Change of The ACCELEROMETER JCSS calibration uncertainty

January 2022
RION CO., LTD.

Difference of assignment value (calibrated value) before and
after the change of specified standard accelerometer
(Representative value)

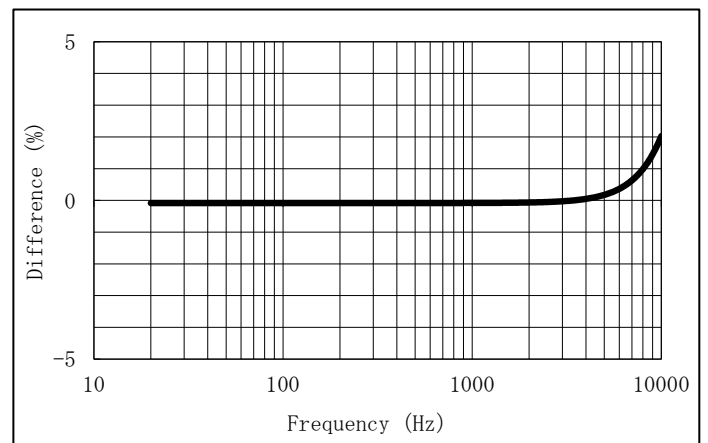
We have changed the specified standard accelerometer in ACCELEROMETER JCSS calibration since the calibration request in November 2021. This has changed expanded uncertainty of calibration. Assignment charge sensitivity (calibrated value) at higher frequency also has changed. (It is now closer to the true value.) This has changed expanded uncertainty of calibration. Assignment charge sensitivity (calibrated value) at higher frequency also has changed. (It is now closer to the actual value.)

Assuming the assignment charge sensitivity (calibrated value) at 10 kHz of PV-90H (serial number 12345) is $0.3000 \text{ pC} \cdot \text{s}^2/\text{m}$, calibrated on October 1, 2021; the assignment charge sensitivity (calibrated value) at 10 kHz of PV-90H (serial number 12345) calibrated on December 27, 2021 is $0.3060 \text{ pC} \cdot \text{s}^2/\text{m}$. (Because difference at 10 kHz is about 2 %, $0.3000 \text{ pC} \cdot \text{s}^2/\text{m} + 0.3000 \text{ pC} \cdot \text{s}^2/\text{m} \times 2 \% = 0.3060 \text{ pC} \cdot \text{s}^2/\text{m}$.)

There is no difference in assignment charge sensitivity (calibrated value) at 80 kHz between October 1, 2021 and December 27, 2021. (Because difference at 80 Hz is 0 %.)
